**RIVERDALE CITY PLANNING COMMISSION AGENDA
CIVIC CENTER - 4600 S. WEBER RIVER DR.
TUESDAY – SEPTEMBER 12, 2023**

3. Consideration of recommendation to City Council for Ken Garff Honda Final Site Plan request, located at approximately 950 West Riverdale Road, Riverdale, Utah 84405, as requested by Kimley Horn and the Ken Garff Automotive Group.

4. Consideration of approval for Panera Bread Preliminary Site Plan request, located at approximately 4130 South Riverdale Road, Riverdale, Utah 84405, as requested by Perigee Consulting and the Panera Bread Group.

SHEET C1.20

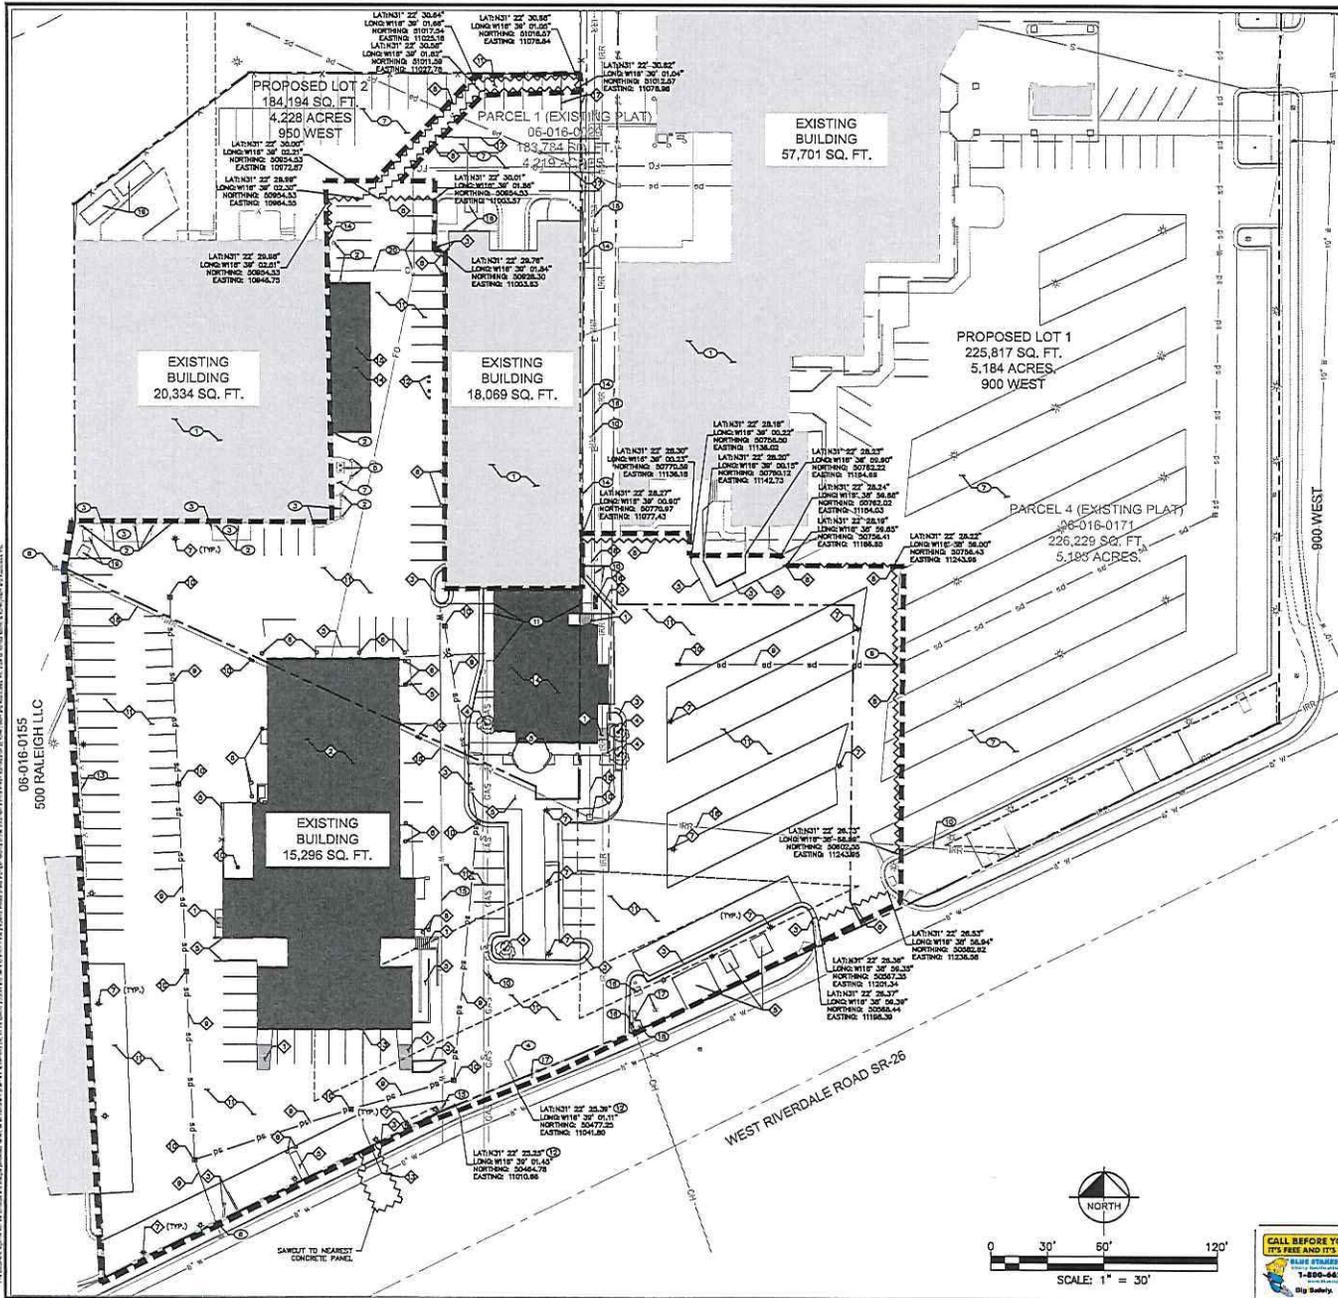
- Could the “not used” Detail 7 Box be removed? The lines are going through the Title block and 811 utility notes. (C1.20)
 - *Response:* The Detail 7 box, along with its text, has been removed.
- Add the State Road number at the end of Riverdale Road. i.e. SR-26 (C1.00)
 - *Response:* Added to all applicable sheets.

SHEET **C2.00**

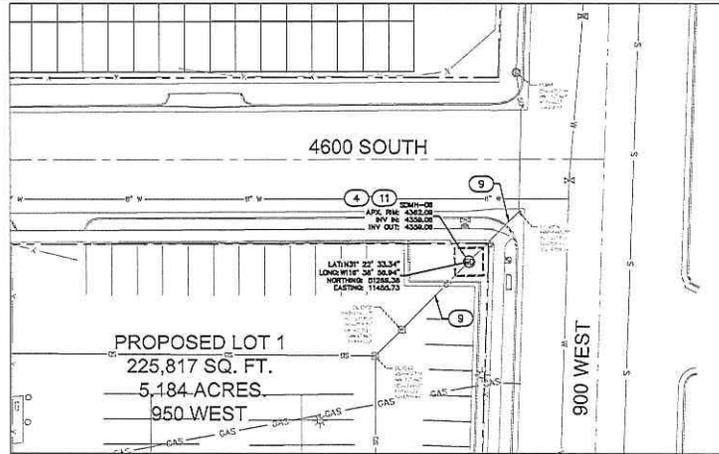
- Building areas don't match/add up for the storm water calculations. (C2.00).
 - **Response:** *The drainage area used for drainage calculations is derived from proposed building areas, not existing building areas. We derived our building drainage areas from our total proposed building area, not the total existing building area. Therefore, the building areas in our drainage report shows a different area that what is shown on our demolition plan.*

- There is an existing irrigation line shown that goes under the proposed building. How is this utility being rerouted? (C2.00)
 - *Response:* Coordinating with the public works and irrigation entity authority over the line to be abandoned and removed.
- Indicate the size of the existing waterline that will be connected to the new line going into the building (C5.00)
 - *Response:* Existing water line updated to include the size.

ORIFICE PLATE DETAIL SCALE: NTS

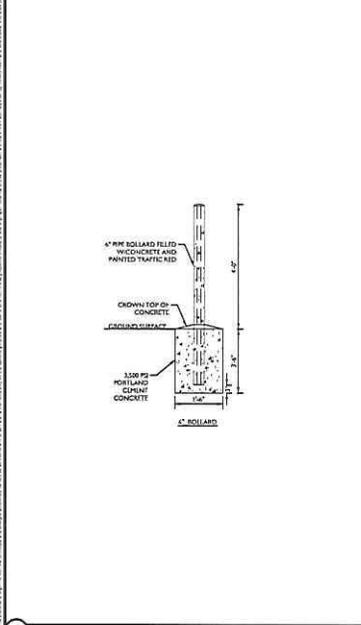
1. There is an existing irrigation line (East) that has been shown but does not show where it continues to the west? Where is the end? (C4.00)
2. The orifice detail does not show any invert elevation or installation data. (C6.60)

- Show the orifice size on the detail drawings.
 - *Response:* Orifice size and detail shown on construction detail sheet C6.60.

SHEET **L1.10**

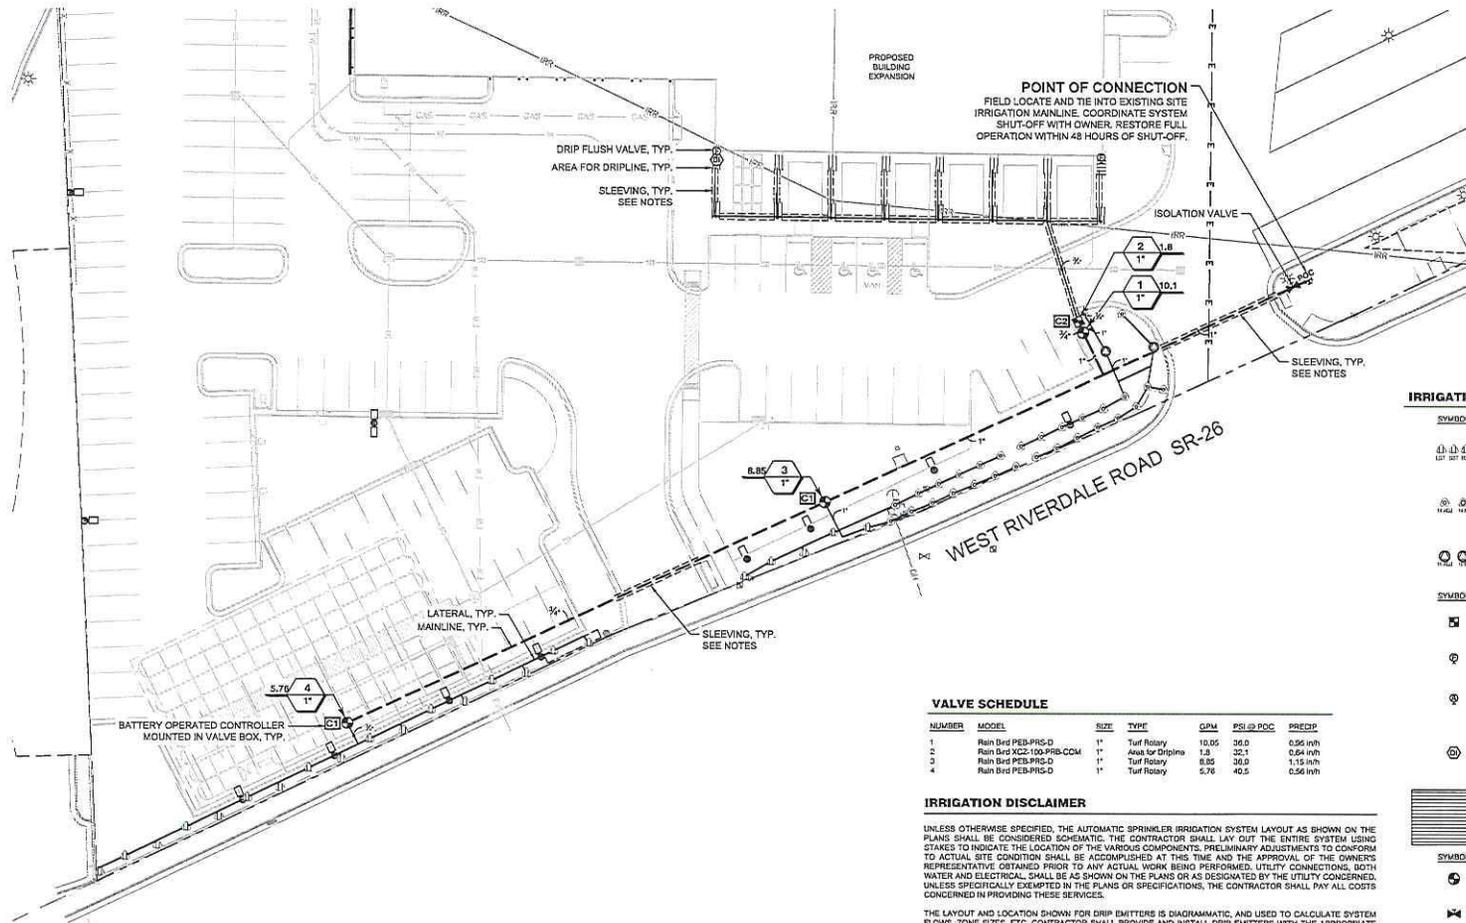
1. Decorative stamped concrete hatch is missing from park island next to building (L1.10)
2. I don't see any plants/shrubs on the layout. The plant schedule indicates that there will be 48+64=112. Need to show locations for planting on the layout.

- The landscaping/irrigation plan(s) are not complete. (L1.10)
 - *Response: Landscape and Irrigation plans updated and complete.*
